MEMORANDUM DATE: October 7, 2020

RE: **224 North L Street**

TITLE: **HRPB Project Number 20-00100186:** Consideration of a Certificate of Appropriateness (COA) for exterior alterations for the property located at **224 North L Street**; PCN#38-43-44-21-15-046-0130. The subject property is a contributing resource to the Northeast Lucerne Local Historic District and is located in the Medium Density Multi-Family Residential (MF-30) Zoning District.

West Elevation (Fronting North L Street)

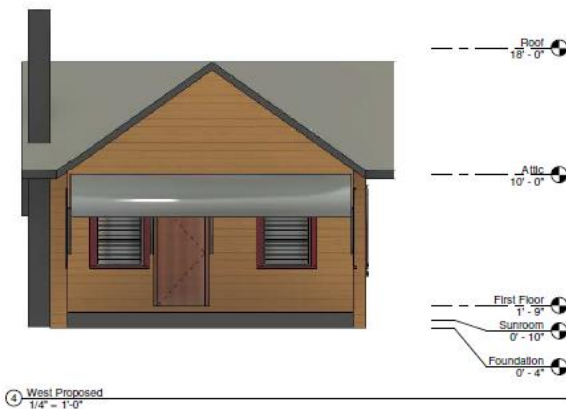
There are no proposed changes or replacement windows on the front façade. With the exception of the front door that will be replaced with a Stevens & Sons fiberglass impact door with a 6-light divided-light pattern. Per the Lake Worth Beach Historic Preservation Design Guidelines, the proposed door is visually compatible with the Wood Frame Vernacular structure.

East Elevation

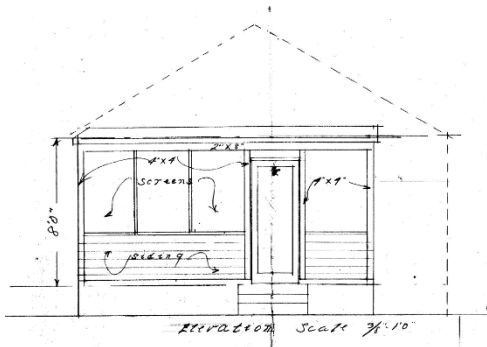
The replacement jalousie windows and door will be reconfigured to accommodate a new PGT aluminum impact single-hung window with a 6/1 divided-light pattern and a pair of French doors with a 10-light pattern.

Based upon the original 1953 elevation drawing, Staff recommends returning the rear porch to screen openings. Another option is utilizing casement windows with divided-light patterns which were typical for enclosed porches in Wood Frame Vernacular structures. A French door with a divided-light pattern is a compatible choice if installed within the original opening size. Staff has included Conditions of Approval to allow the Applicant to replace the existing windows and doors in the existing openings with compatible alternatives in accordance with the Lake Worth Beach Historic Preservation Design Guidelines requirements on window and door replacement for historic structures.

There are several options for compatible alternatives. Retaining the greatest number of original openings is recommended. However, if new opening sizes are desired Staff recommends replicating the dimensions of original openings. The structure has original openings that likely accommodated hung and casement windows that can be replicated in size and appearance. Apart from altering the opening size, the proposed pair of French doors is a compatible option.

North Elevation

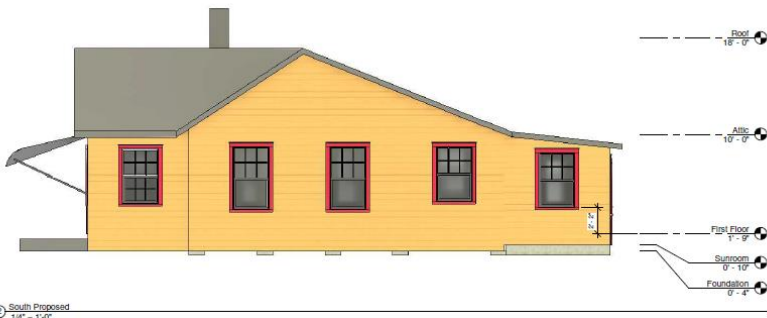
A rear opening with a jalousie window will be enclosed. Three (3) openings will be enlarged to accommodate PGT aluminum impact single-hung windows. A new triangular PGT aluminum impact fixed glass window is proposed below the gable end. In addition, the jalousie window in the front enclosed porch will remain.

Based upon the existing original opening sizes, the replacement jalousie windows should be replaced with single-hung and casement windows as illustrated in the Wood-Frame Vernacular style section of the Lake Worth Beach Historic Preservation Design Guidelines, depicted below. Original openings sizes should not be enclosed or altered. Staff has included Conditions of Approval to allow the Applicant to replace the existing windows and doors in the existing openings in accordance with the Lake Worth Beach Historic Preservation Design Guidelines requirements on window and door replacement for historic structures.

There are several options for compatible alternatives. Retaining the greatest number of original openings is recommended. However, if new opening sizes are desired Staff recommends utilizing the dimensions of original openings. The structure has original openings that likely accommodated hung and casement windows that can be replicated in size and appearance.

South Elevation

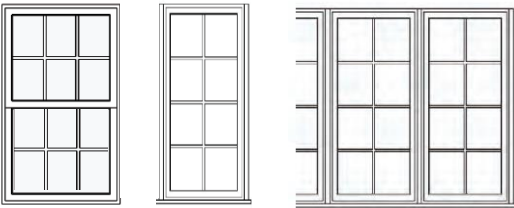
Rear openings with a jalousie windows will be removed. Four (4) openings will be reconfigured to accommodate PGT aluminum impact single-hung windows. In addition, the original wood-hung window will remain in the front enclosed porch.

Based upon the existing original opening sizes, the replacement jalousie windows should be replaced with single-hung and casement windows as illustrated in the Wood-Frame Vernacular style section of the Lake Worth Beach Historic Preservation Design Guidelines, depicted below. Original openings should not be enclosed or altered. Staff has included Conditions of Approval to allow the Applicant to replace the existing windows and doors in the existing openings in accordance with the Lake Worth Beach Historic Preservation Design Guidelines requirements on window and door replacement for historic structures.

There are several options for compatible alternatives. Retaining the greatest number of original openings is recommended. However, if new opening sizes are desired Staff recommends utilizing the dimensions of original openings. The structure has original openings that likely accommodated hung and casement windows that can be replicated in size and appearance.
